# Access Compliance Report

## Public Rights-of-Way

Intersection ID: 46919	Main Street: SHADBRUSH_CT	Cross Street: BLUE_ASH_LN	Location: S
ADA ID: DFA973188320	Ramp Type: PerpDiag	Initial Pass/Fail: Pass	Overall Compliance: No
		Severity Score: 7.75	
Codes/Mitigation Info/Possible Solution		Field Measurements/Component Compliance

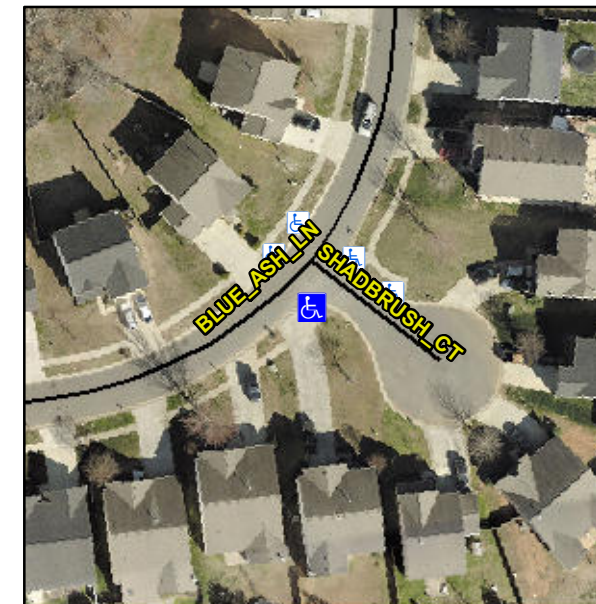
**Not Found, R304.5.3, R304.2.2-Perp, R304.3.2-Para, R305.2, R302.7, R302.7.2**

Compliance	Description	Data	Compliance	Description	Data
N/A	Ramp Length (in)	79.0	Yes	Ramp Slope (%)	5.3
Yes	Ramp Width (in)	48.0	No	Ramp XSlope (%)	3.1
N/A	Flare Type LT	Sloped	N/A	Flare Type RT	N/A
N/A	Flare Slope LT (%)	7.6	N/A	Flare Slope RT (%)	5.2
N/A	Flare Traversable LT?	No	N/A	Flare Traversable RT?	No
Yes	Landing Length (in)	49.0	Yes	DWS Provided?	Yes
Yes	Landing Width (in)	50.0	Yes	DWS Contrast?	Yes
No	Landing Slope (%)	5.0	Yes	DWS Length (in)	24.5
No	Landing X Slope (%)	3.3	Yes	DWS Full Width?	Yes
N/A	Landing Curb? (Y/N)	No	No	DWS Offset (in)	3.0
N/A	Shared Landing?	No			
No	Gutter Ponding?	Yes	Yes	Gutter Slope (%)	2.1
No	Gutter Lip Ht (in)	0.5	No	Gutter X Slope (%)	2.2
N/A	Painted X Walk1?	No	N/A	Painted X Walk2?	No
	X Walk 1 Direction	To NE		X Walk 2 Direction	To NW
N/A	X Walk 1 Width (in)	N/A	N/A	X Walk 2 Width (in)	N/A
	X Walk 1 Slope (%)	0.6		X Walk 2 Slope (%)	0.7
	X Walk 1 X Slope (%)	1.9		X Walk 2 X Slope (%)	0.5

**Remove & Replace Curb Ramp With Two New Directional Ramps or Equivalent. Remove & Replace Gutter.**
